PERMIT

P 515 325-B

SEWAGE DISPOSAL SYSTEM
HOWARD COUNTY HEALTH DEPARTMENT
BUREAU OF ENVIRONMENTAL HEALTH
410-313-2640

SUBDIVISION Big Branch Overlook LOT NUMBER .5 ADDRESS 14025 Big Branch Drive

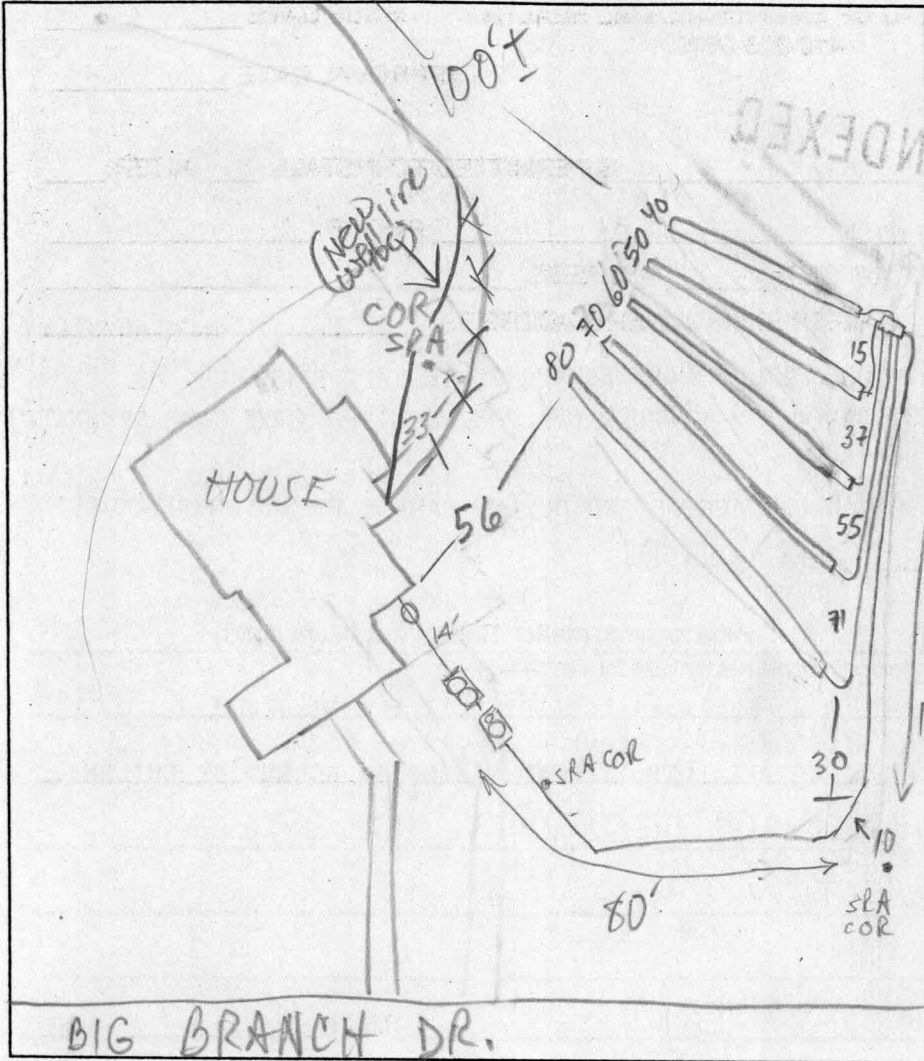
LOCATION: Place the distribution box 135 feet up the right (197.99') lot line and 10 feet off this same lot line. Run (5) trenches on contour as shown on plan.

7/23/01 p.m. OK to install trenches as proposed. OK to continue. DKC

7/24/01 p.m. Needs house connection. OK to cover first two trenches and continue. DKC

7/25/01 DUE TO VARIABLE TOPO, ROOM FOR ONE REPAIR REMAINS; OK TO COVER TANKS + TRENCHES; HOLD FOR PUMP/ALARM

8-17-01 Pump TEST OK
